HISTORIC PRESERVATION BOARD STAFF REPORT

516 N. Swinton Avenue

Meeting	File No.	Application Type
August 5, 2026	HP-526-2026	Certificate of Appropriateness, Demolition, Variance, & Waiver

The item before the Board for consideration of a Certificate of Appropriateness (HP-526-2026), Demolition, Variance and Waiver requests for a second-floor addition to an existing non-contributing one-story garage structure for use as a guest cottage for the property located at **516 N. Swinton Avenue (Harden-Hart House), Individually Designated to the Local Register.**

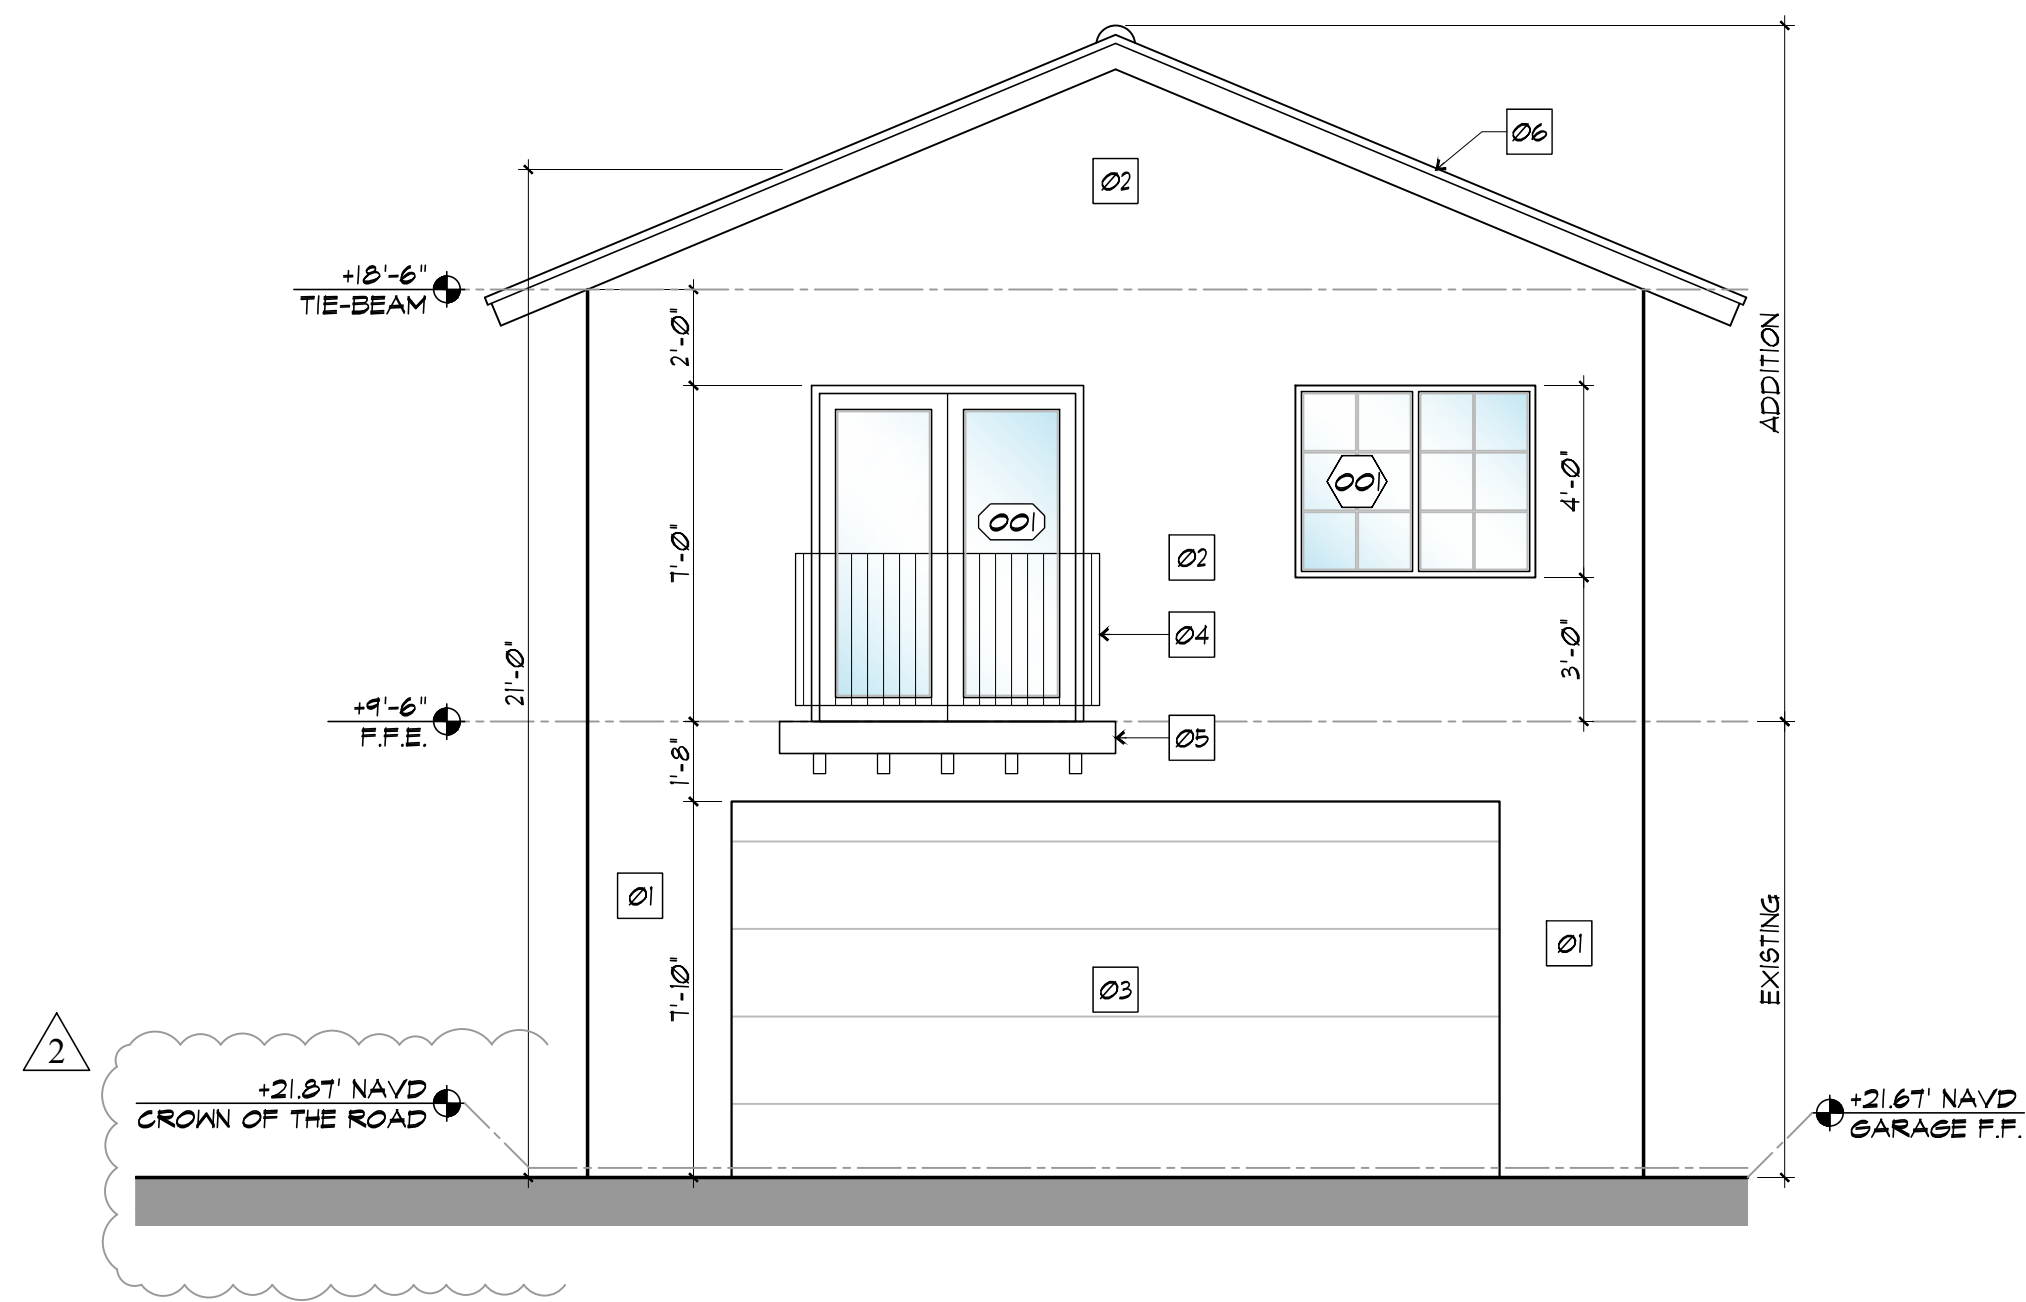
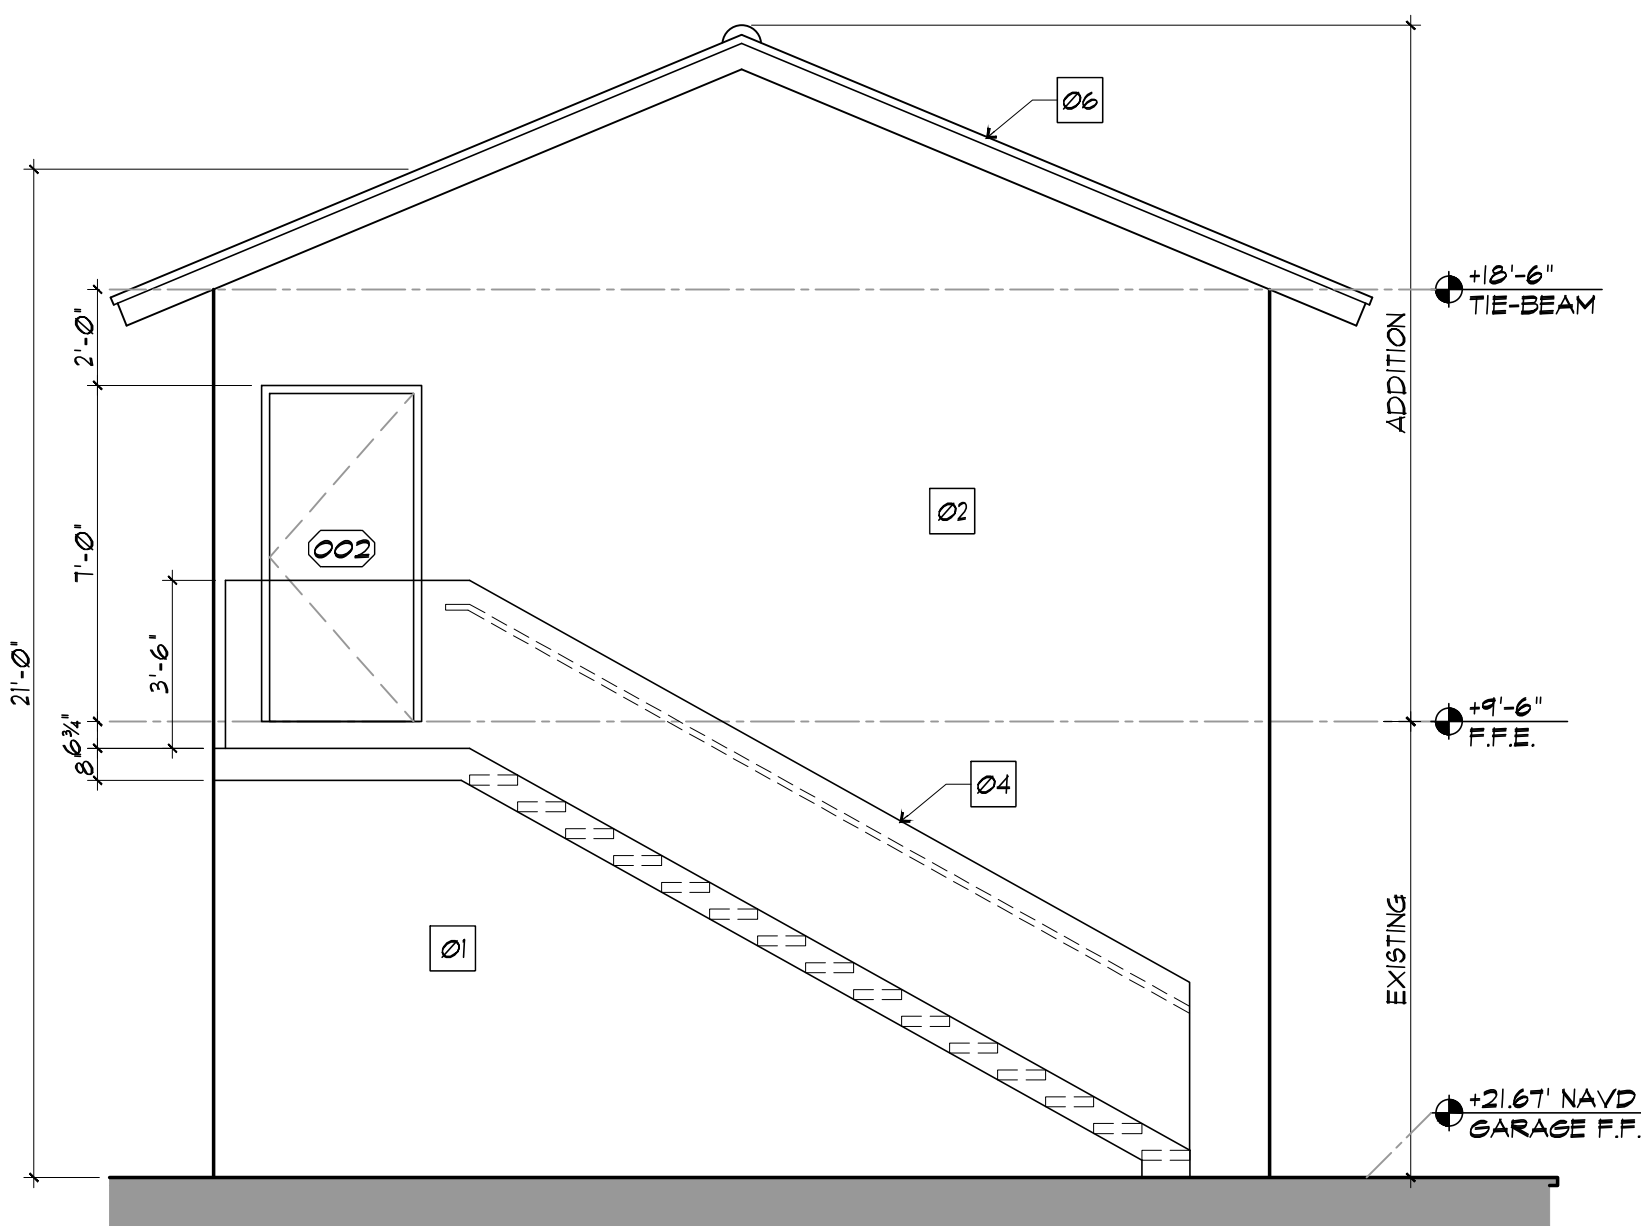
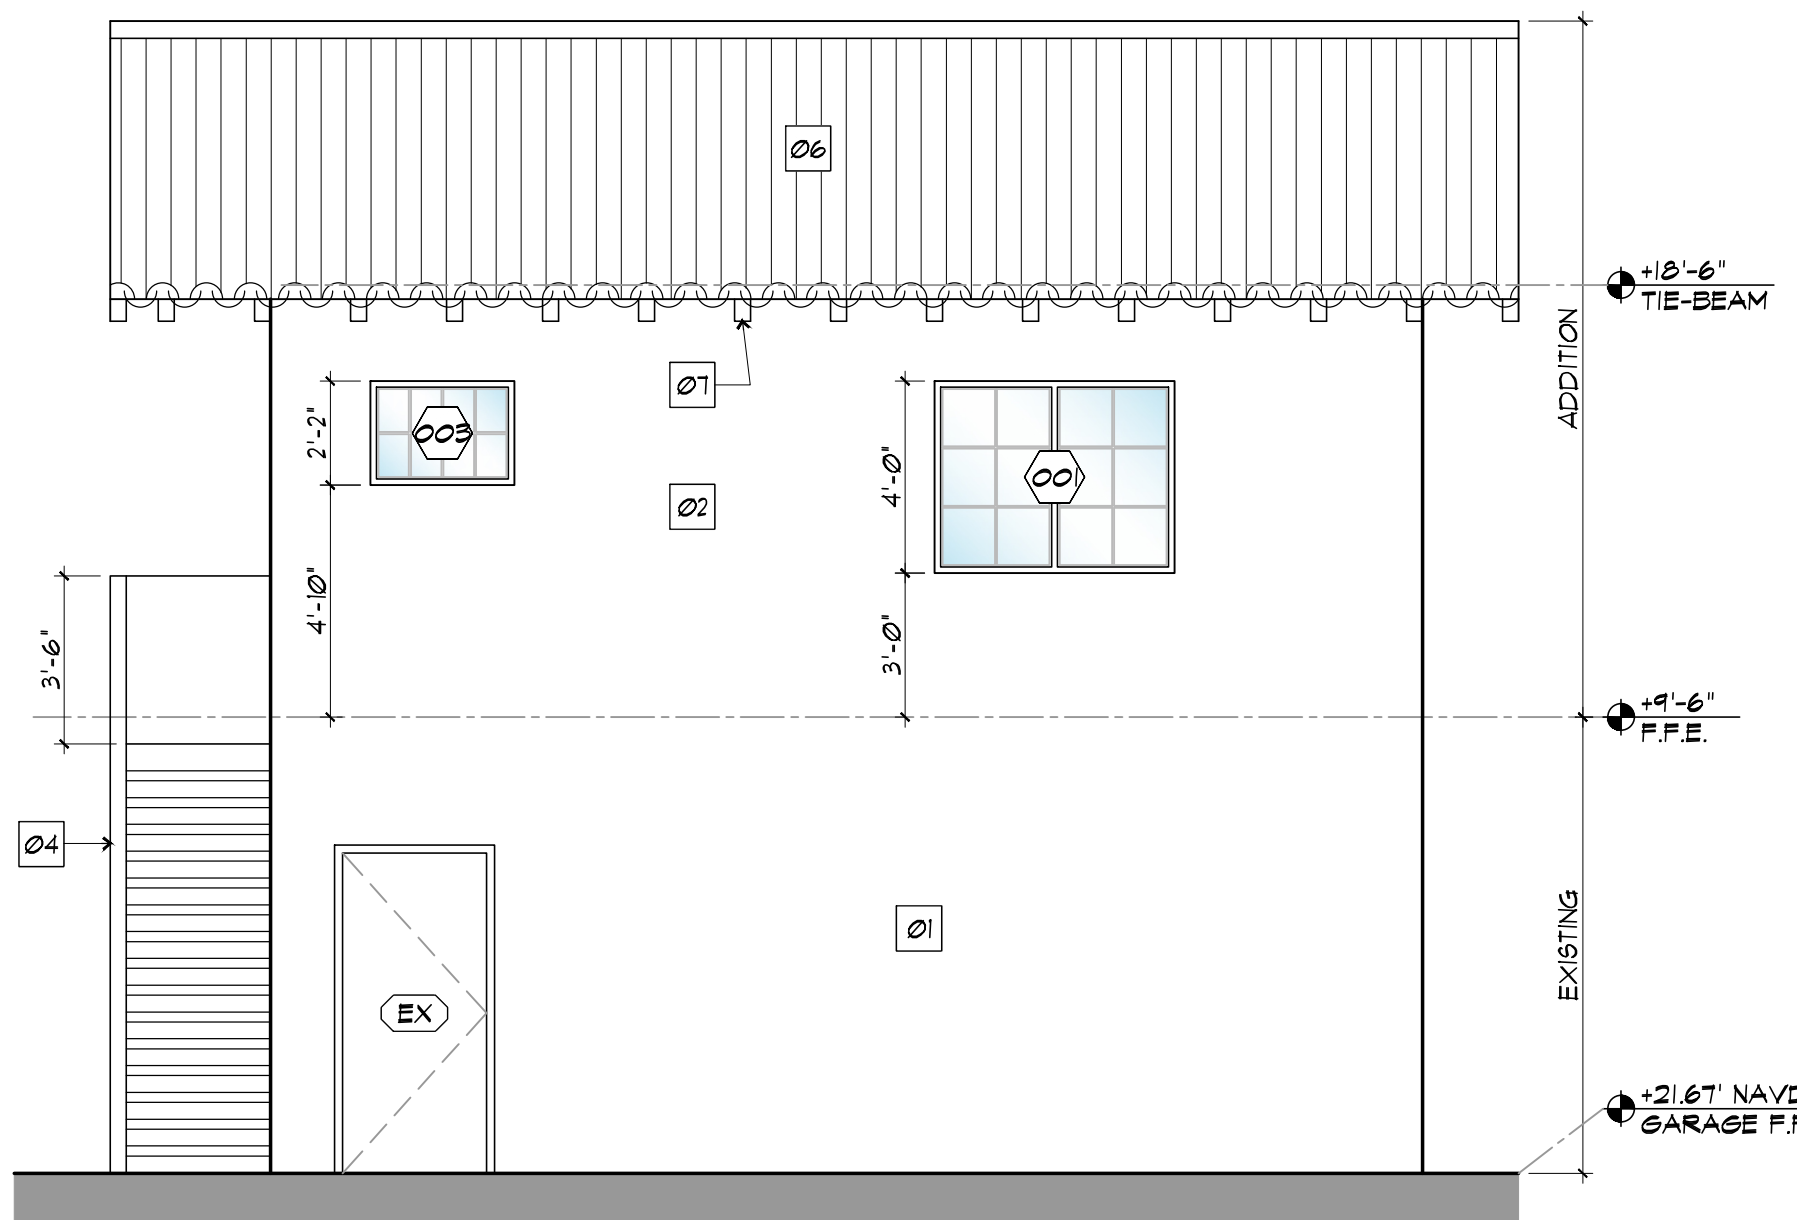
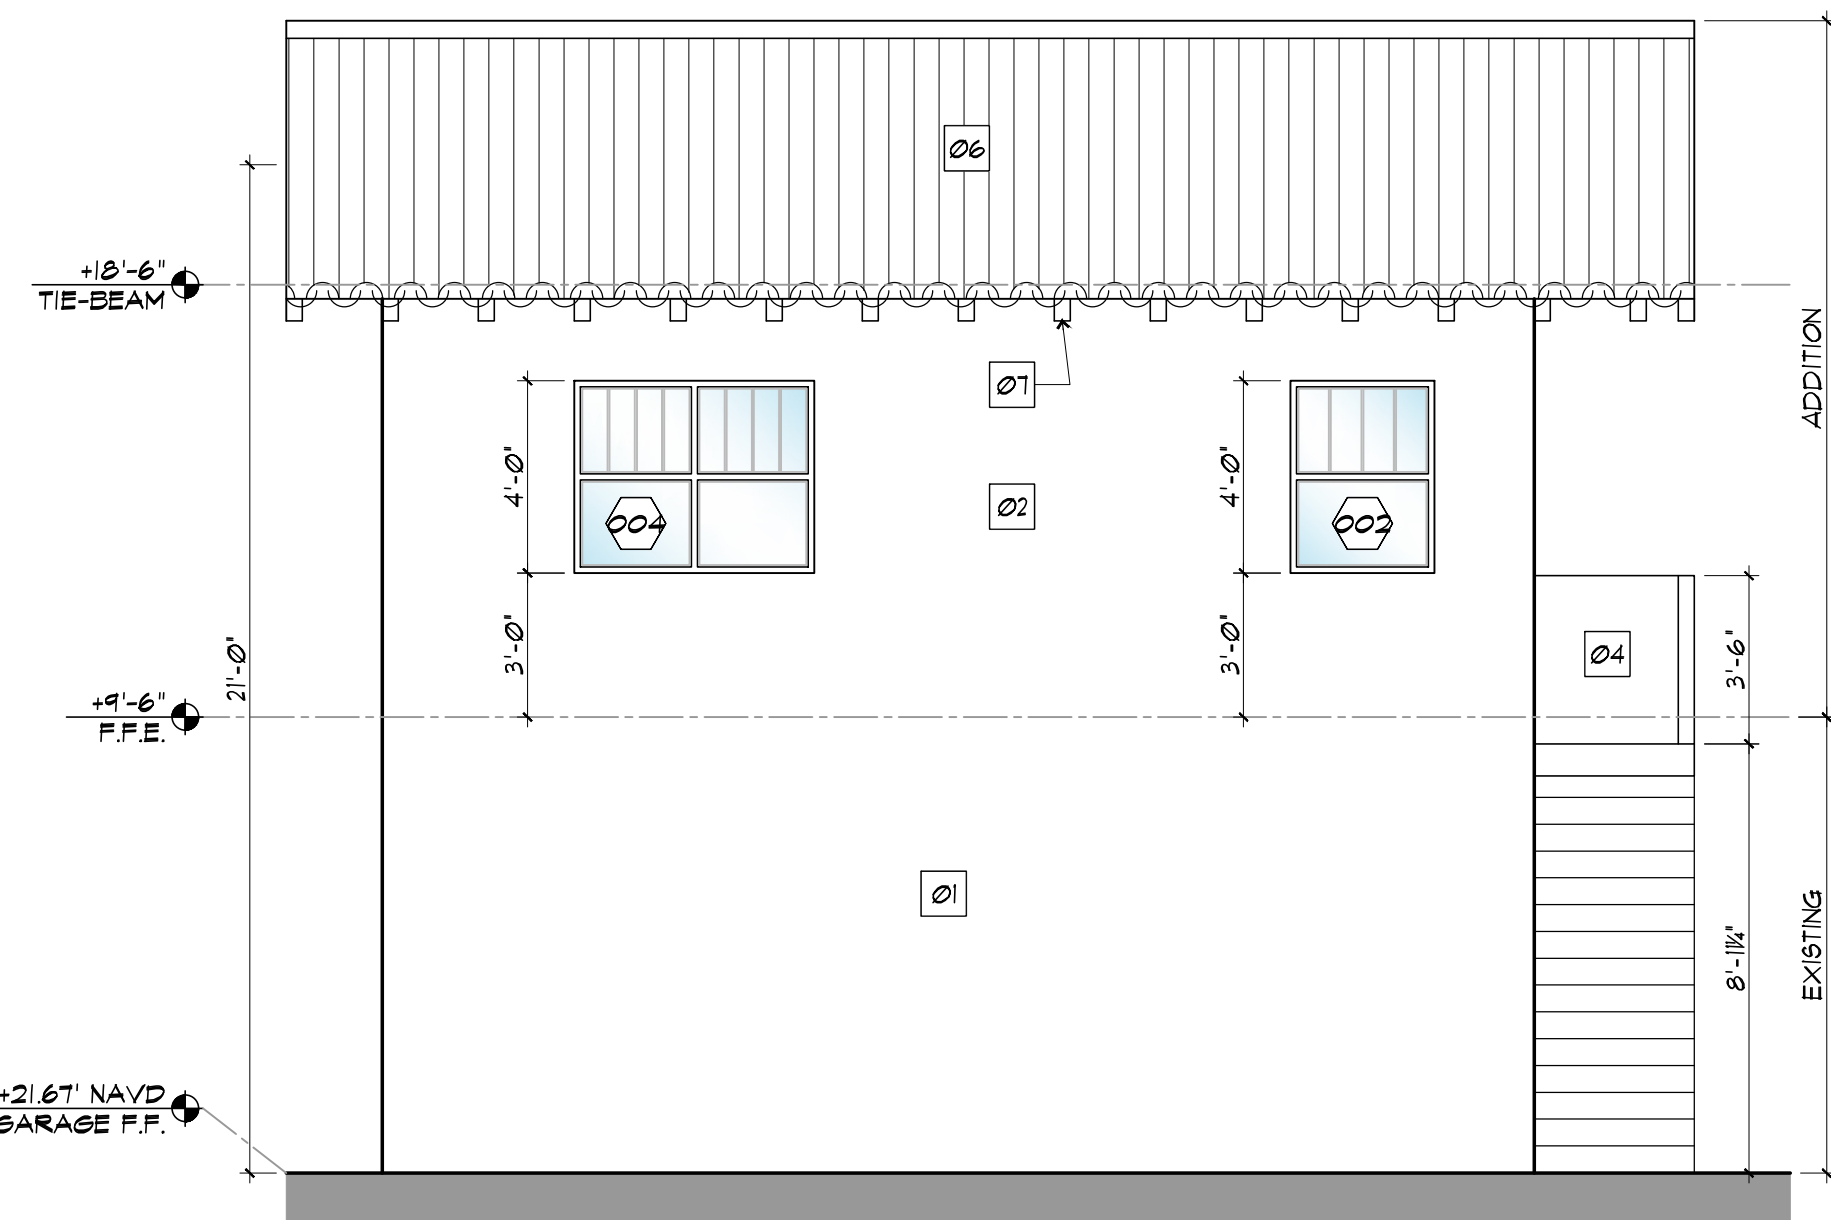
With respect to Height, the Land Development Regulations indicate that accessory structures are not permitted to be taller than the principal structure. The proposal meets the requirements, as it is shorter than the principal structure by 3 feet 3¼ inches. There will be a height change for the rear accessory structure changing from an existing one-story structure at 9 feet 6 inches to 21 feet for the second story addition. The proposed roof profile will retain the same appearance as exists on the accessory garage structure, which is currently compatible with the principal structure. The proposed materials and colors can also be seen as appropriate as the textured siding, barrel tile roofing, black aluminum balcony railing, and white window frame/glass colors are elements either currently seen on the principal structure or compatible with the Mediterranean Revival architectural style.

There is concern with the amount of blank walls proposed, however. As the existing accessory structure is designed as a garage, there is little fenestration and existing blank walls along the east, south, and west elevations (the north contains the garage door). The proposed second story guest cottage addition introduces openings and a Juliette balcony that weren't previously on the structure, however, the ground floor retains the blank walls around the garage. Consideration could be given to additional fenestration or architectural detailing along the ground floor, and along the south elevation in its entirety, although this elevation is not visible from the public right-of-way. The proposed windows are to utilize similar window types as the existing does, which include four-over-one and six panel fixed windows. The slight differentiation between the existing three-over-one windows on the principal structure and the proposed four-over-one windows on the addition will provide subtle distinction between old and new. Regarding additions, the proposed guest cottage is detached from the principal structure. It will be located on the rear/least public portion of the site, be behind the front wall plane of the historic structure, utilize appropriate materials/finishes, and can be seen as secondary subordinate to the principal structure. The proposal is not anticipated to overwhelm the original building.
